TURTLE CREEK SEWER LINE RELOCATION

Solicitation Number: CO-00167

Job No.: 18-4518

ADDENDUM 1

TURTLE CREEK No. 3 SEWER LINE RELOCATION
SANITARY SEWER PLAN & PROFILE
SHEET 1 OF 4

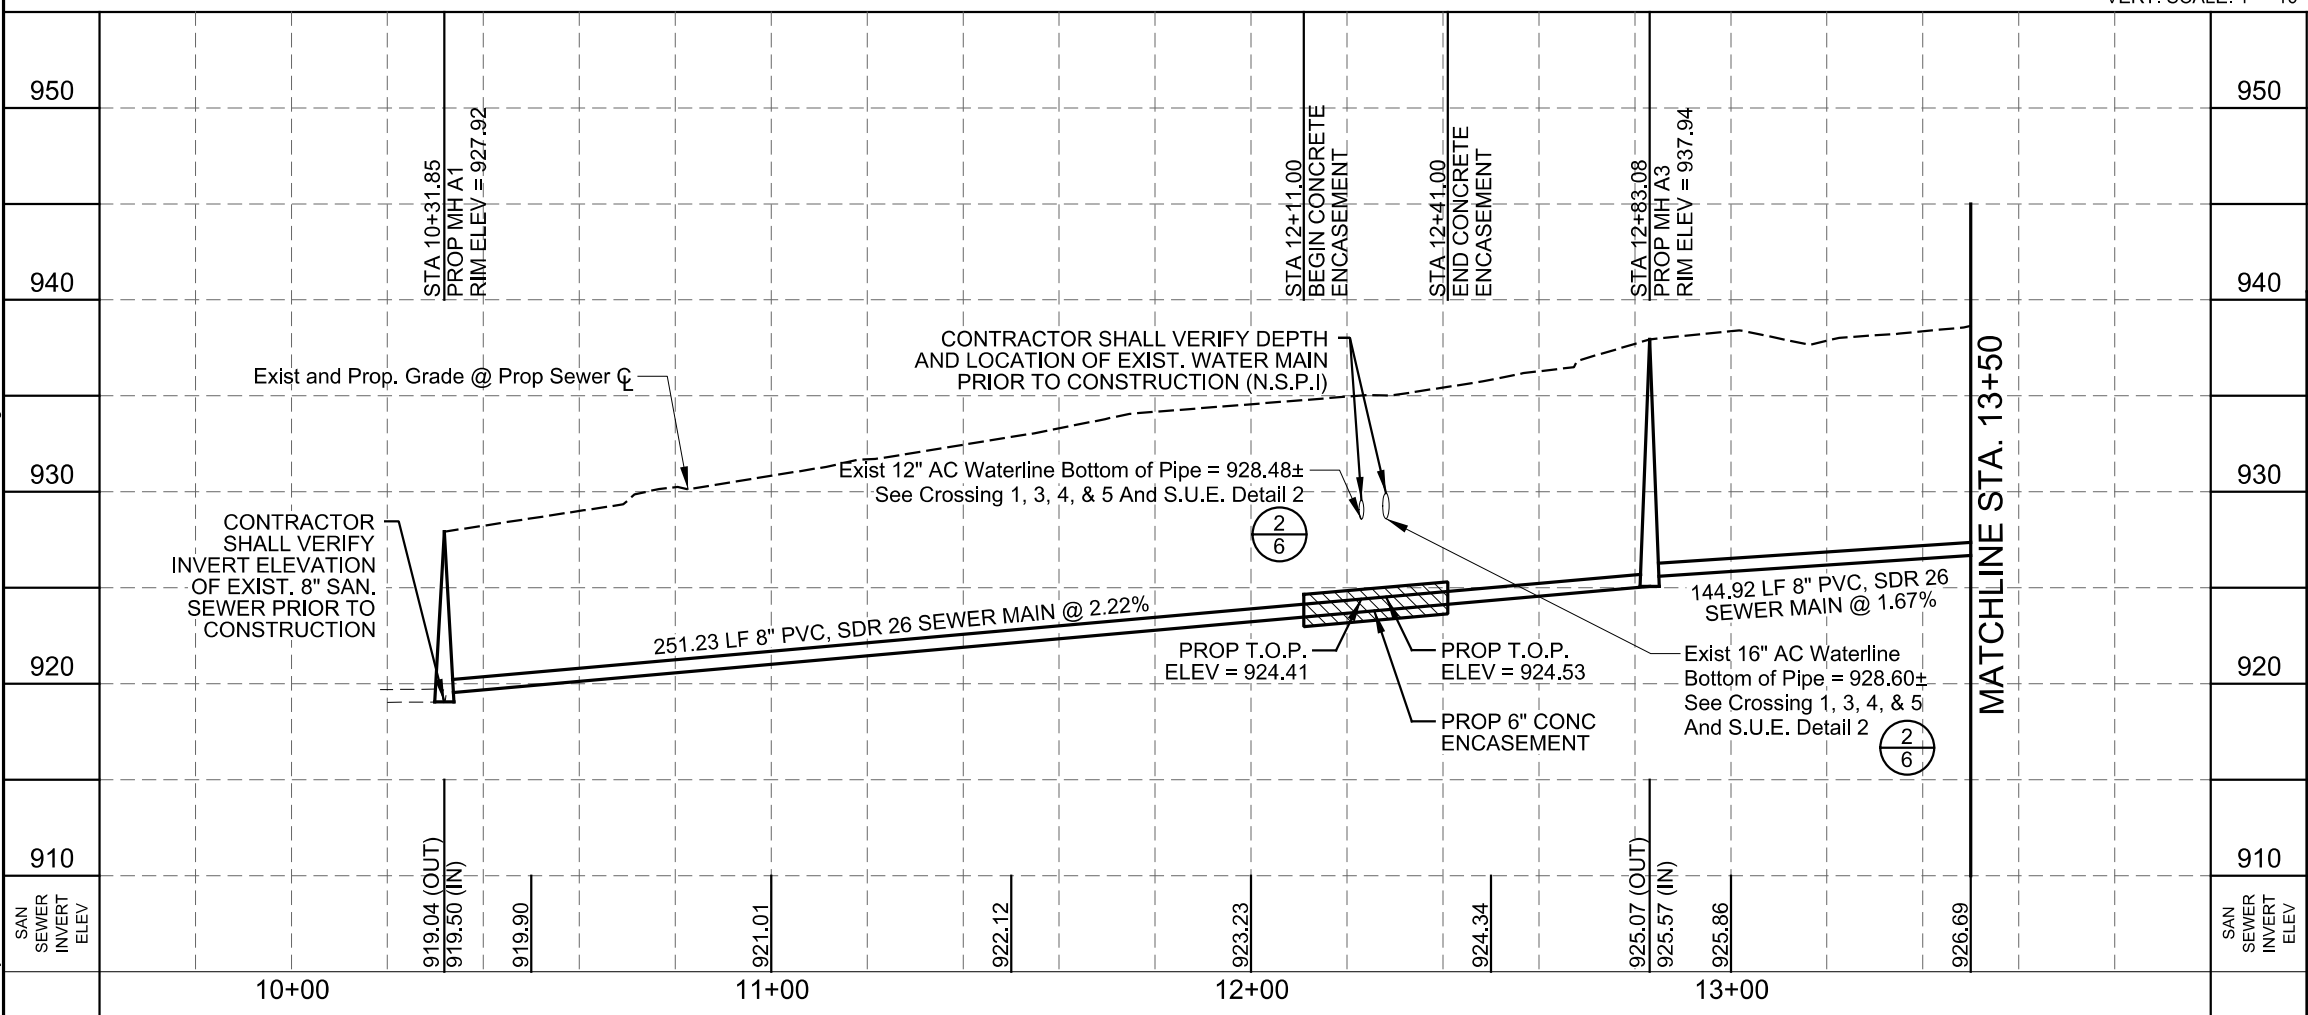
10. In reference to page 7 of the project plans, it states to “remove and replace wooden fence... NSPI”. Can SAWS provide limits for this non-pay item or provide a quantity?

The length of fencing to be removed and replaced needs to be limited to the width of the sanitary sewer easement (16 feet). If removal of more than 16 feet of fence is needed, Contractor will have to coordinate with adjacent landowner(s).
